No: PCB/ Ramanagara/ Mother Earth/ NGT/WMC/2021-22/110 DATE: 20/9/2021

**Inspection Report of Sri Vasudeva S.K, SEO, Zonal Office, KSPCB ,Bangalore South.**

1	Name and Address of the TSDF inspected	Mother Earth Environ Tech Pvt. Ltd Plot No.217, KIADB Industrial Area ,2 <sup>nd</sup> Phase, Harohalli, Kanakapura Taluk, Ramanagara District
3	Category and classification	Small Size Landfill site less than 5 hectares (4 Acres)- Large- Red
4	Person's Contacted	Sri Renukaradhya, Senior Manager Tech & operations & operations and Sri Sanjay Gowda – In charge
5.	Date of inspection.	20.09.2021
6.	Consent and authorization status	Having valid consent under Water and Air Acts for the period up to 30.06.2021 and also authorization under HWM Rules,2016 for the period up to 30.06.2021

The TSDF authorities have constructed three collection tanks of capacity 30 KL, 15 KL & 50KL for collecting the storm water from the TSDF

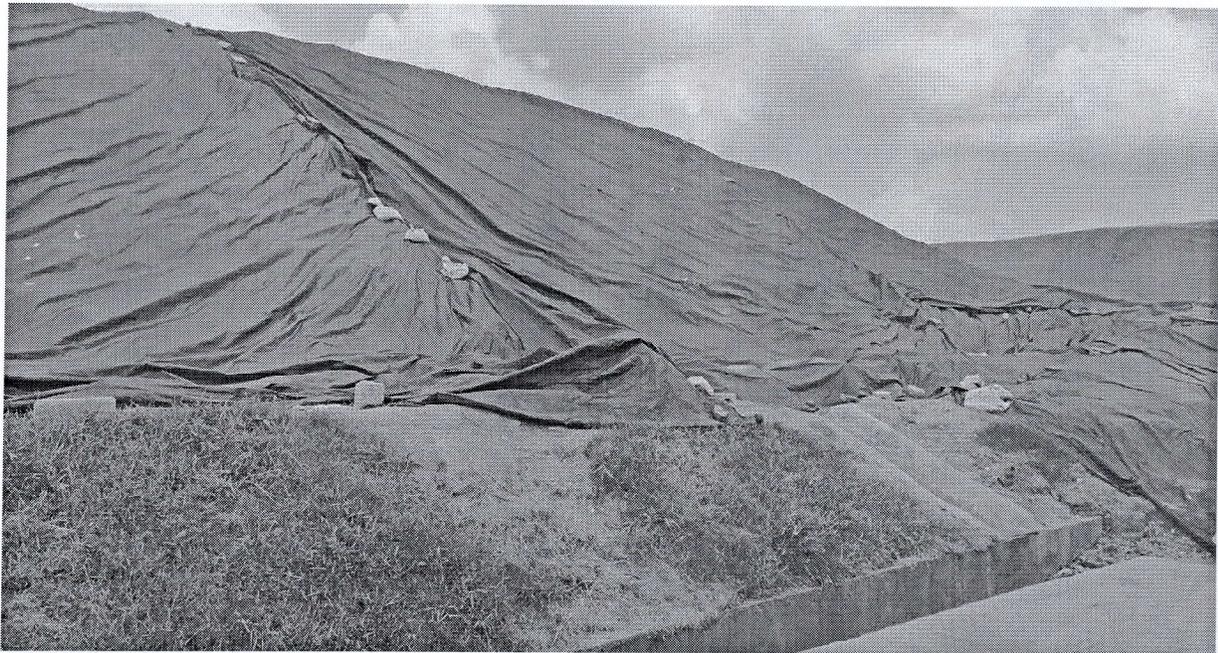
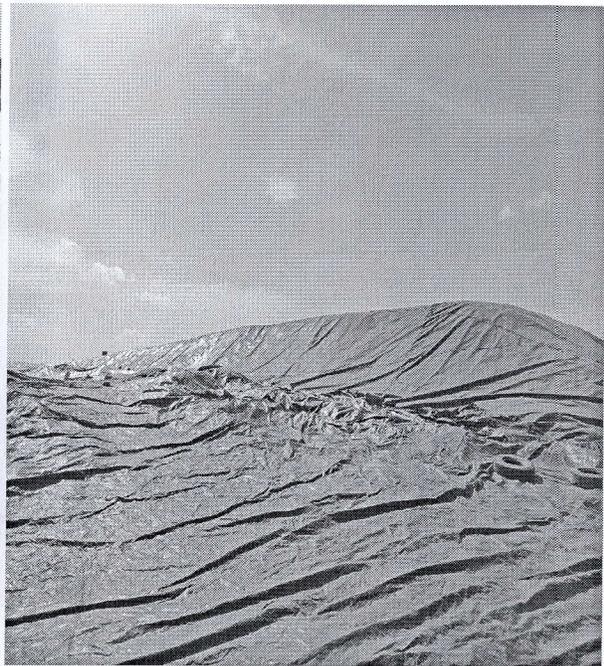
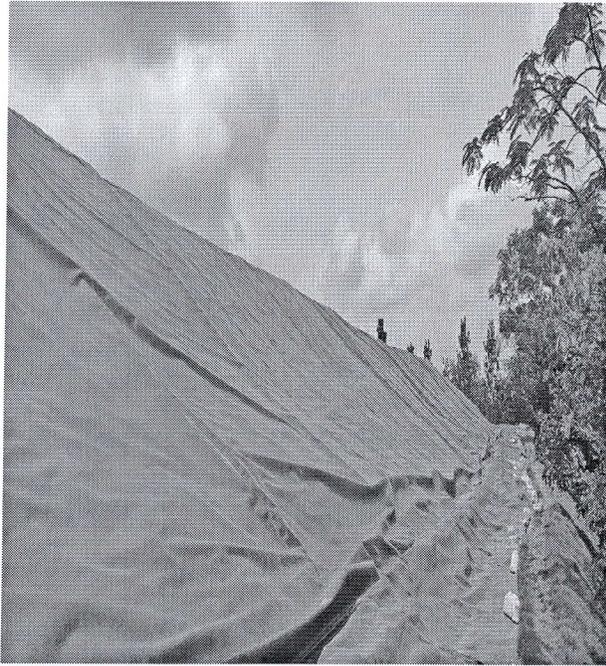
Management of surface runoff	Page No.37 and Para No.7.5	The TSDF authorities have provided storm water drains (garland canals) on East, West & North side for collection of surface runoff and they have constructed three collection tanks of capacity 30 KL, 15 KL & 50KL for collecting the storm water from the TSDF and pumping the same to the pre treatment plant/ leachate collection tank and neutralized and disposed to CETP-M/s Bangalore Eco Park.
